APPLICATION NO.	FILING DATE	FIRST NAMED INVENTOR	ATTORNEY DOCKET NO.	CONFIRMATION NO.
10/605,663	10/16/2003	Ronald S. Lane		2662

Office Action Summary	Application No. 10/605,663	Applicant(s) LANE, RONALD S.	
	Examiner Gwendolyn Baxter	Art Unit 3632

This is the third office action for application serial no. 10/605,663, Bookstand that Folds Thin Enough to serve as a Bookmark filed October 16, 2003.

Diagram 6

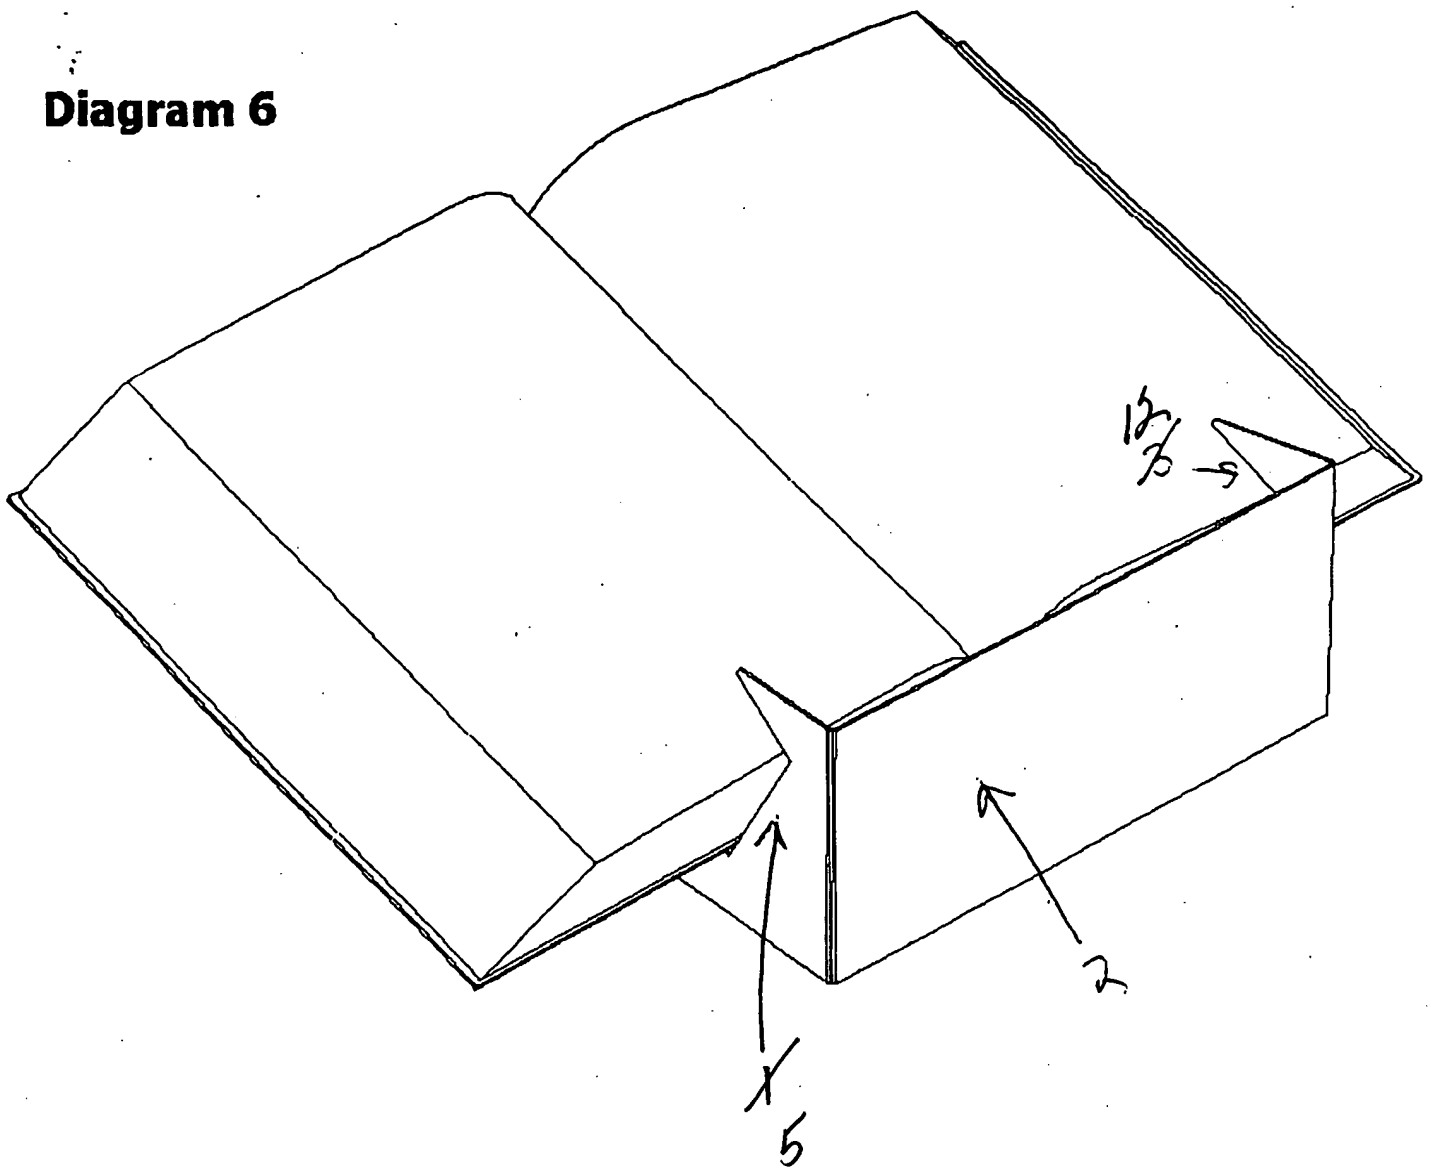
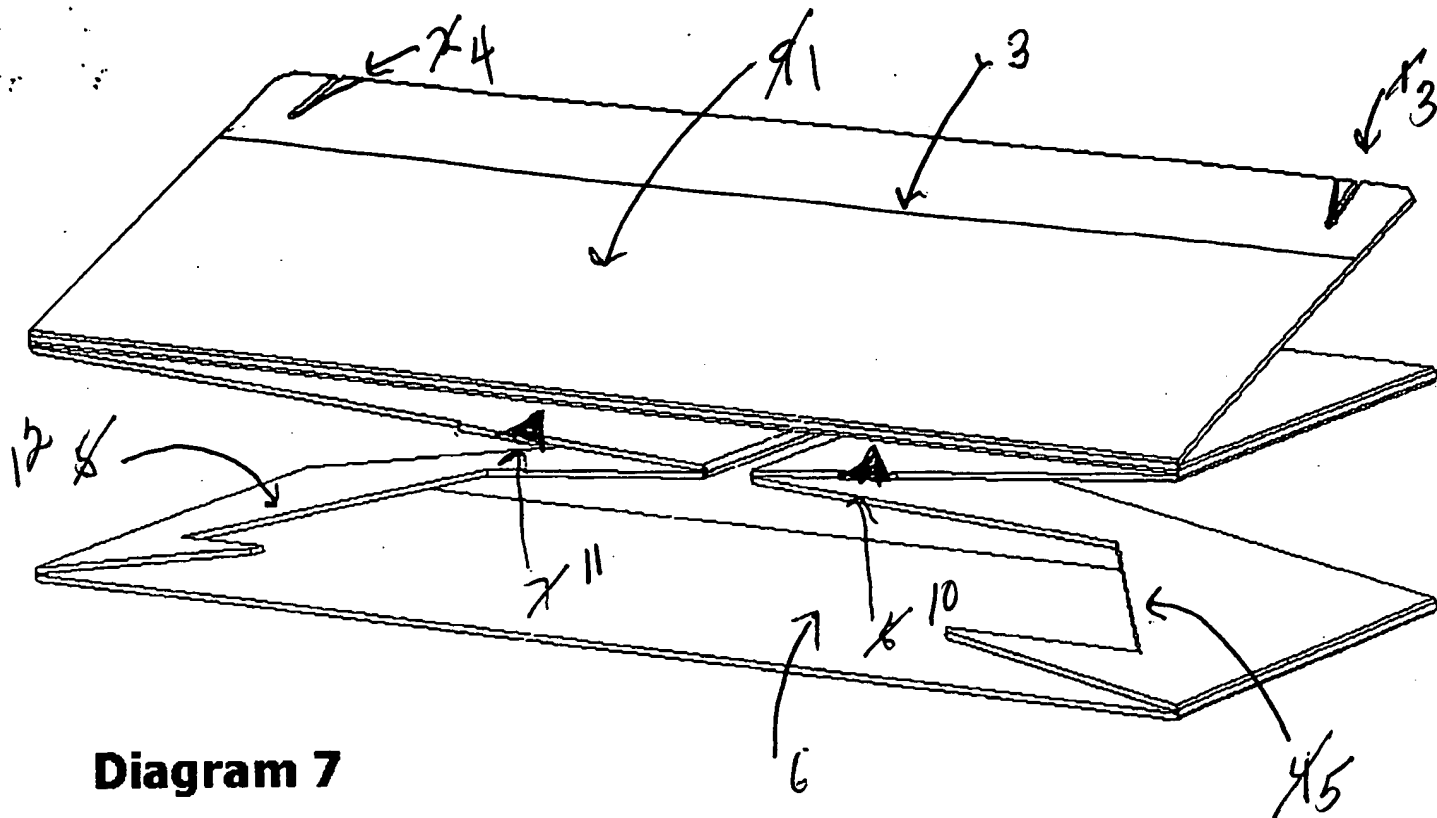
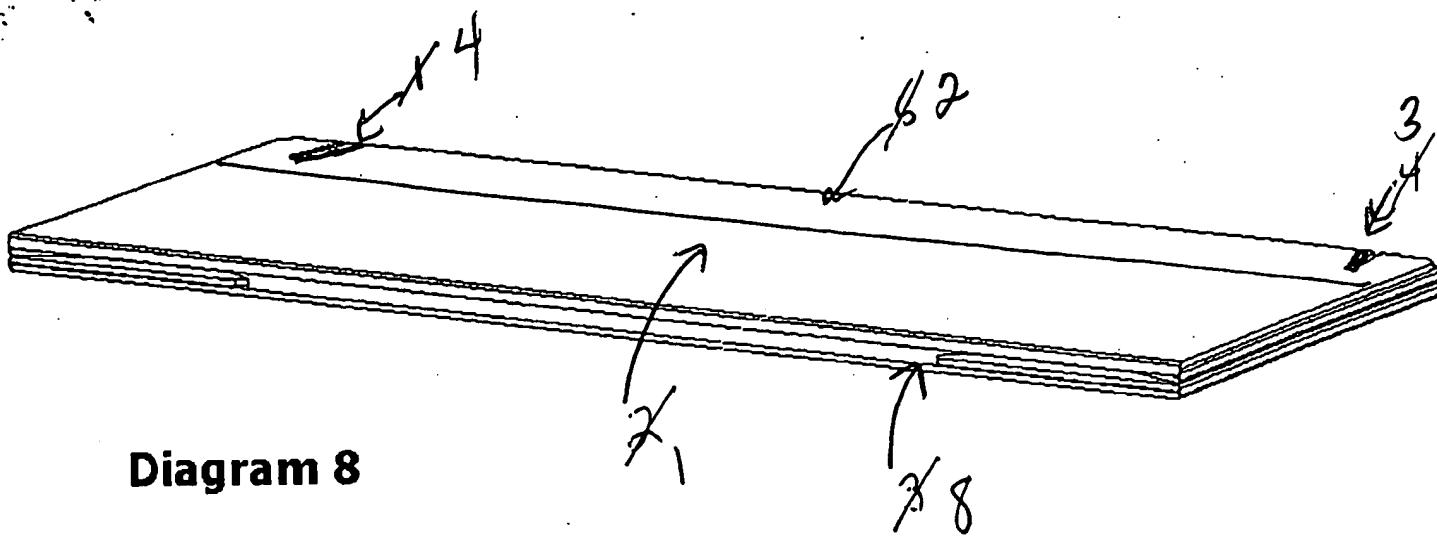
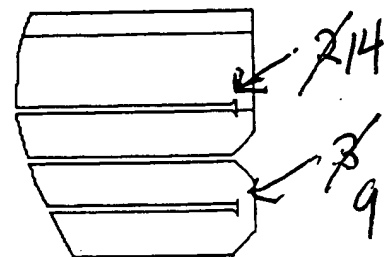
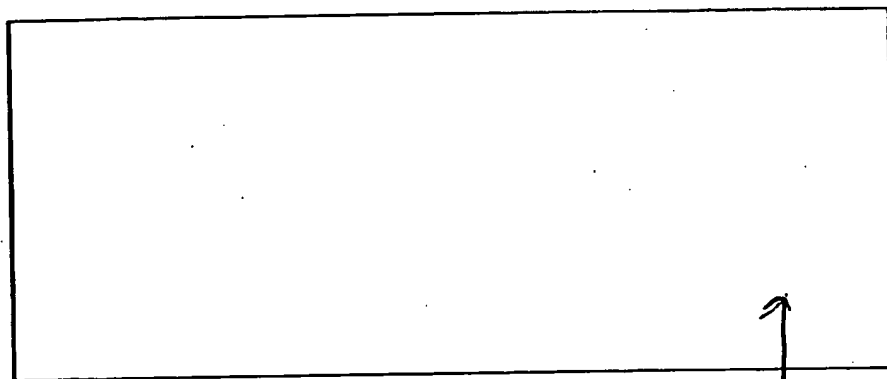
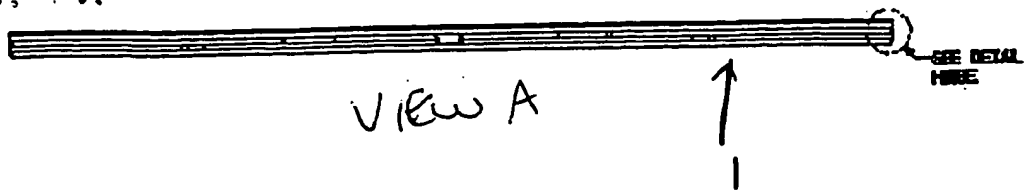
In order to reconcile the reference numerals in the specification and drawings, the following suggestions are made to correct different parts with the same reference numerals and/or different numbers for the same part. See modified copy of the drawing supplied by the examiner.

Corrected drawing sheets in compliance with 37 CFR 1.121(d) are required in reply to the Office action to avoid abandonment of the application. Any amended replacement drawing sheet should include all of the figures appearing on the immediate prior version of the sheet, even if only one figure is being amended. Each drawing sheet submitted after the filing date of an application must be labeled in the top margin as either "Replacement Sheet" or "New Sheet" pursuant to 37 CFR 1.121(d). If the changes are not accepted by the examiner, the applicant will be notified and informed of any required corrective action in the next Office action. The objection to the drawings will not be held in abeyance.
